Access Compliance Report

Public Rights-of-Way

(Curb Ramps)

Intersection ID: 50475	Main Street: BRONWIN_ST	Cross Street: S_TRYON_ST	Location: NW
ADA ID: 927D6F7C00F6	Ramp Type: Perp	Initial Pass/Fail: Fail	Overall Compliance: No
		Severity Score: 8.75

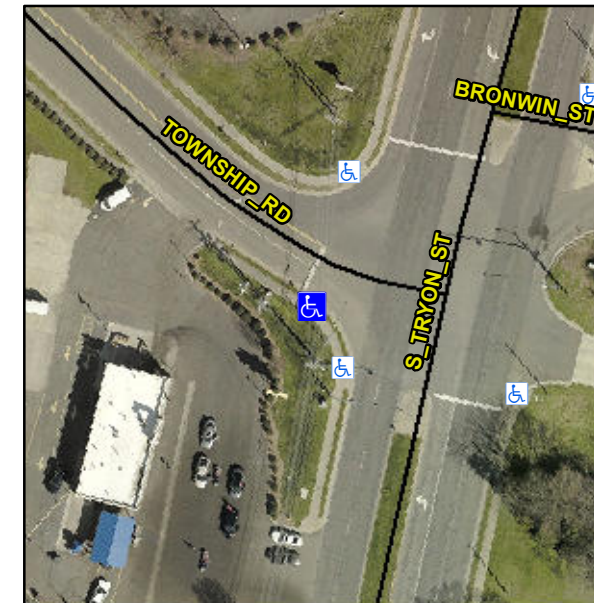
Not Found, R304.5.1

Compliance	Description	Data	Compliance	Description	Data
N/A	Ramp Length (in)	31.0	Yes	Ramp Slope (%)	7.6
No	Ramp Width (in)	45.0	Yes	Ramp XSlope (%)	1.9
N/A	Flare Type LT	N/A	N/A	Flare Type RT	N/A
N/A	Flare Slope LT (%)	N/A	N/A	Flare Slope RT (%)	N/A
N/A	Flare Traversable LT?	N/A	N/A	Flare Traversable RT?	N/A
N/A	Landing Length (in)	N/A	N/A	DWS Provided?	N/A
N/A	Landing Width (in)	N/A	N/A	DWS Contrast?	N/A
N/A	Landing Slope (%)	N/A	N/A	DWS Length (in)	N/A
N/A	Landing X Slope (%)	N/A	N/A	DWS Full Width?	N/A
N/A	Landing Curb? (Y/N)	N/A	N/A	DWS Offset (in)	N/A
N/A	Shared Landing?	N/A			
N/A	Gutter Ponding?	N/A	N/A	Gutter Slope (%)	N/A
N/A	Gutter Lip Ht (in)	N/A	N/A	Gutter X Slope (%)	N/A
N/A	Painted X Walk1?	No	N/A	Painted X Walk2?	N/A
	X Walk 1 Direction	To NE		X Walk 2 Direction	N/A
N/A	X Walk 1 Width (in)	N/A	N/A	X Walk 2 Width (in)	N/A
	X Walk 1 Slope (%)	1.5		X Walk 2 Slope (%)	N/A
	X Walk 1 X Slope (%)	2.1		X Walk 2 X Slope (%)	N/A

Remove & Replace Entire Ramp.
